RE: ACU-23-074 & FP-23-012 Beaver Slough Drainage District

**Winter Lake Phase III
Tidal Restoration Project**

USACE
Request For Additional Information 2
Coos SWCD/ODFW
11/11/23

Figure 25. c. Large Woody Debris Map

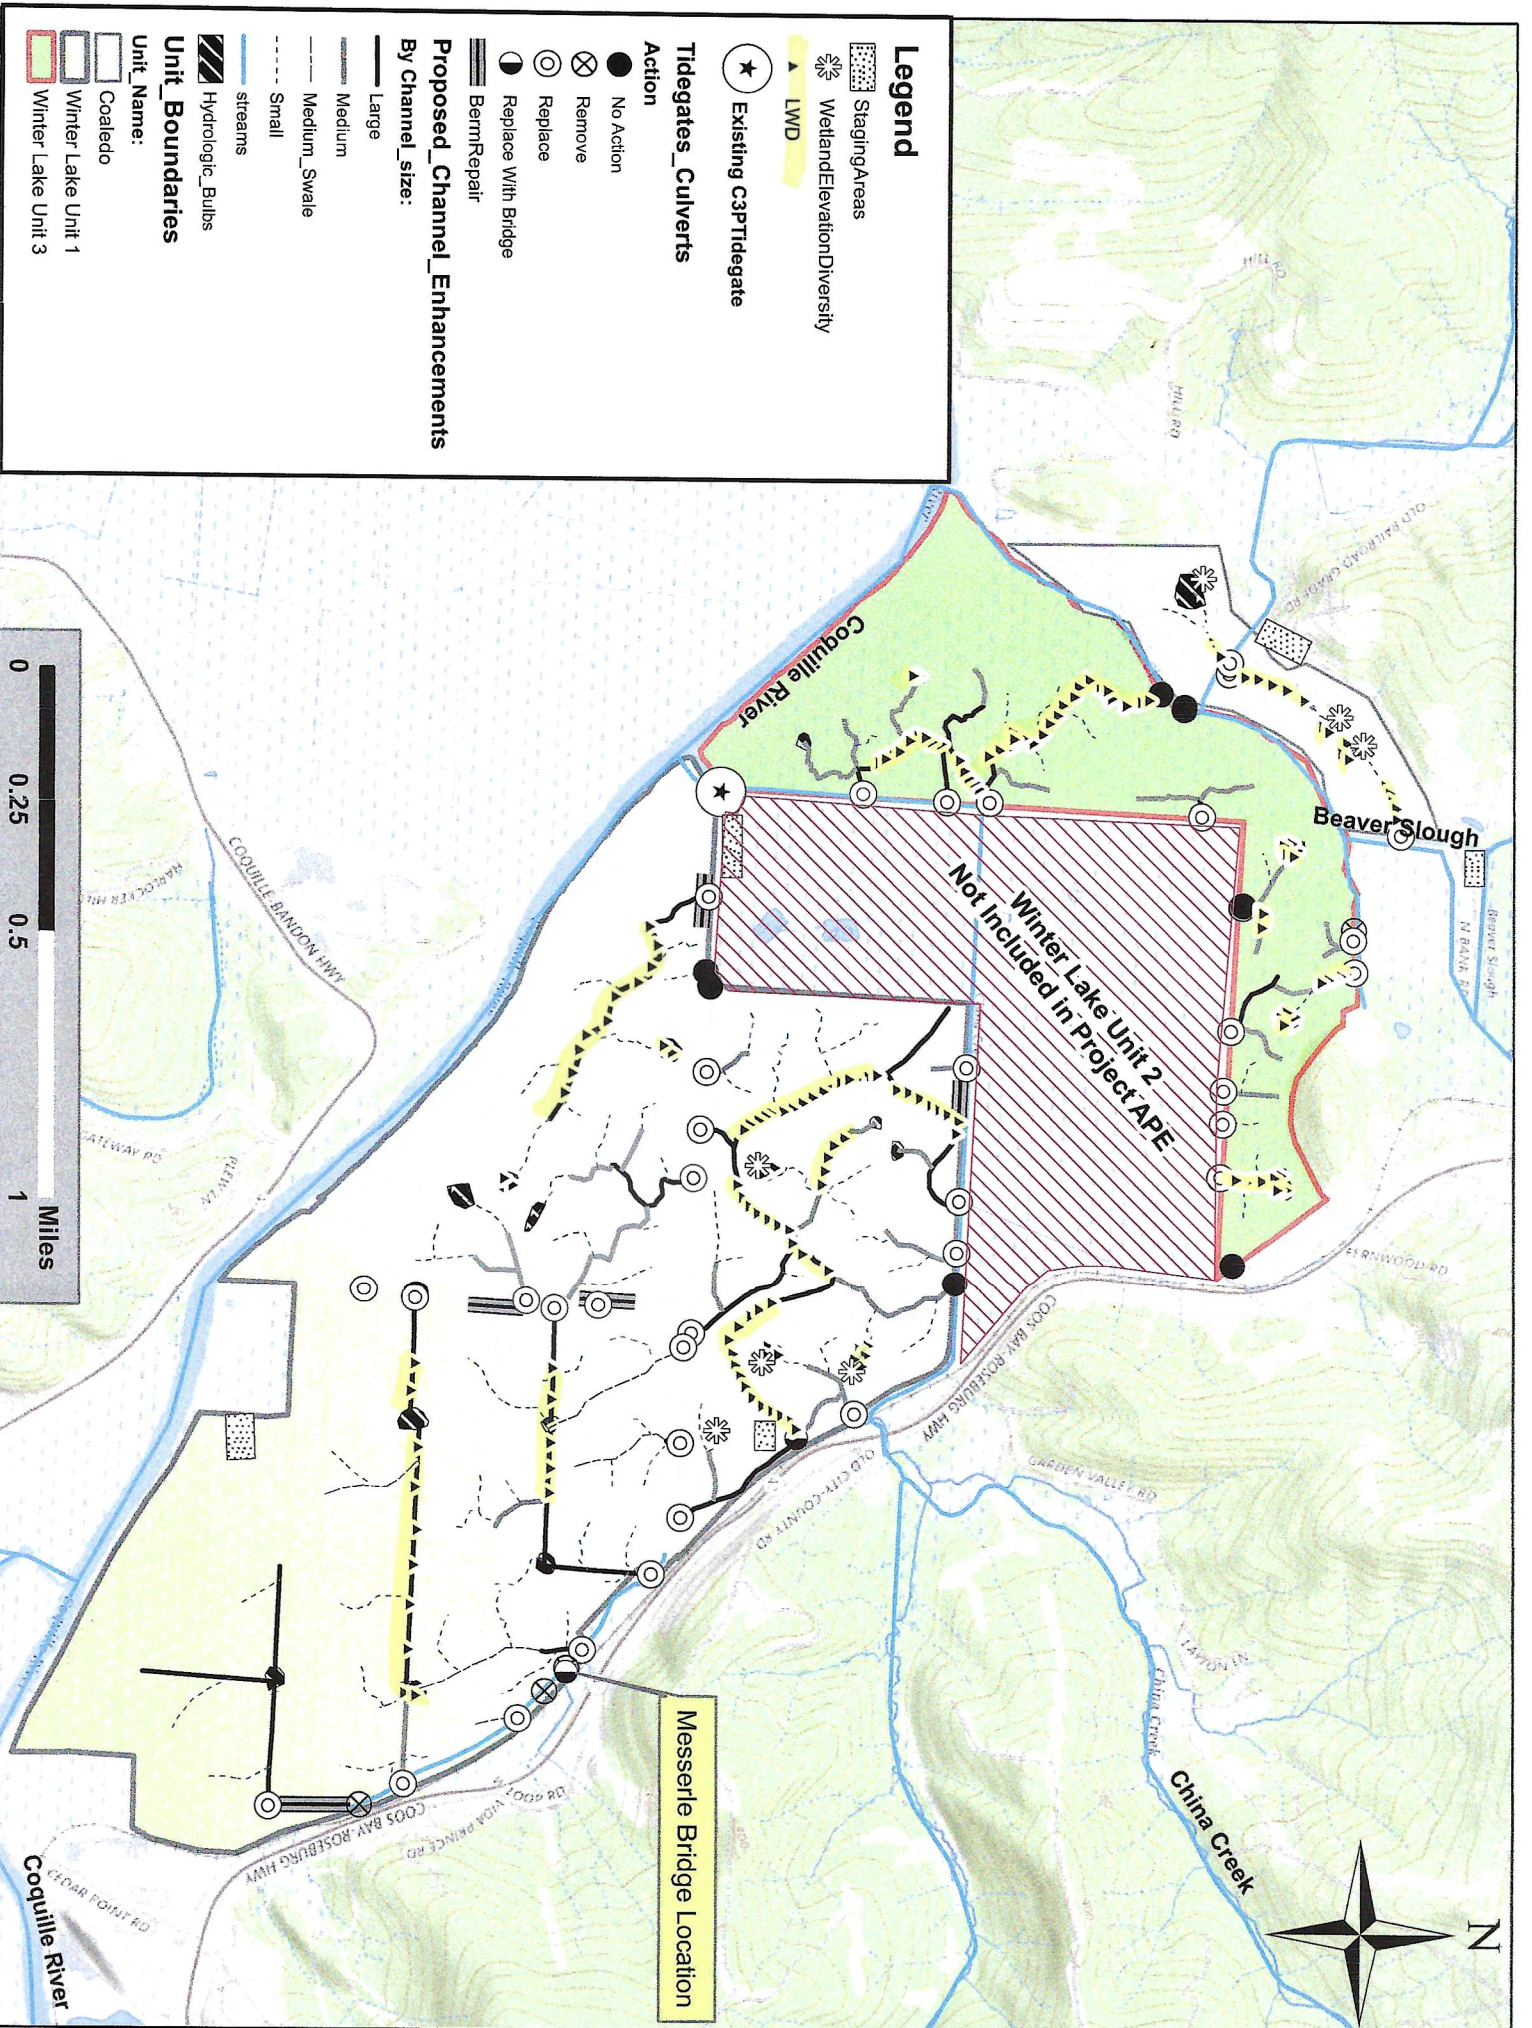
- d. For the installation of 200 pieces of large woody debris to be placed at strategic locations at the individual owner's discretion, provide the location of these large wood placements, the size and length of the large wood, volume and area of impact to wetlands and/or waters. Clarify if rock fill material would be utilized to hold the large wood in place; if rock fill material is proposed clarify its location, dimensions, and area of impact as described above.

- We have developed Figure 25. C. in Attachment A. Figures and Photos FINAL revised 9_15_23, denoting the locations for LWD. The total yardage for LWD placement per log of 2.9cy per log with a total CYs of 586.1. Logs with root wad attached will be placed inserted at 45° or lesser angle to a minimum insertion depth of 8.0ft. The insertion depth will result in sufficient skin friction on the stem to maintain LWD stable without dislodging during flooding events. The upright placement also reduces floatation effects as there is not the ability for buoyancy leverage on the log stem. Figure 1. below is a typical insertion depiction as denoted for another SWCD project.

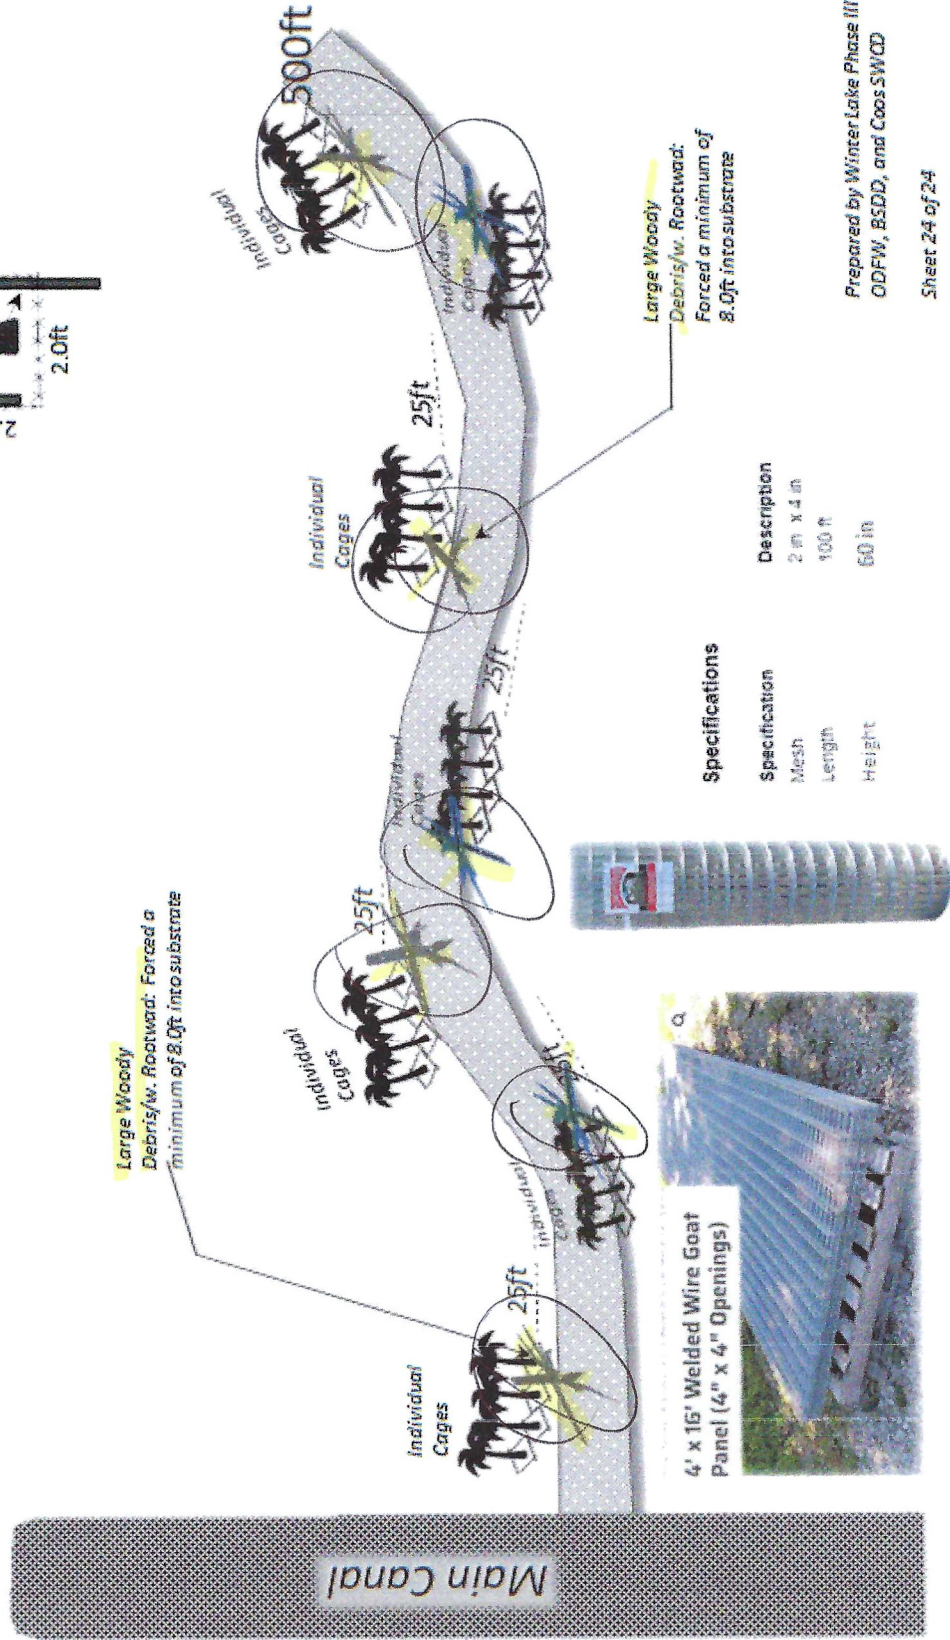
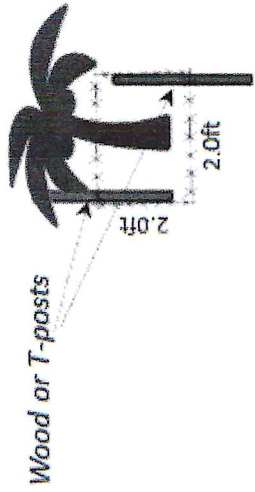
USACE 6). Provide the dimensions of the Large Woody Debris. Fill in the blanks or modify this sentence to communicate a range of sizes:

The applicant would add 200 pieces of large woody debris measuring approximately ____ feet long and ____ inches wide at 12 locations to restore fish habitat.

Team Response: The Large Woody Debris will be installed with the stem inserted into the soils to a depth where only the rootwad is exposed (Figures 4 and 5). The stems will average 12ft in length and the average log will be 15" in diameter..
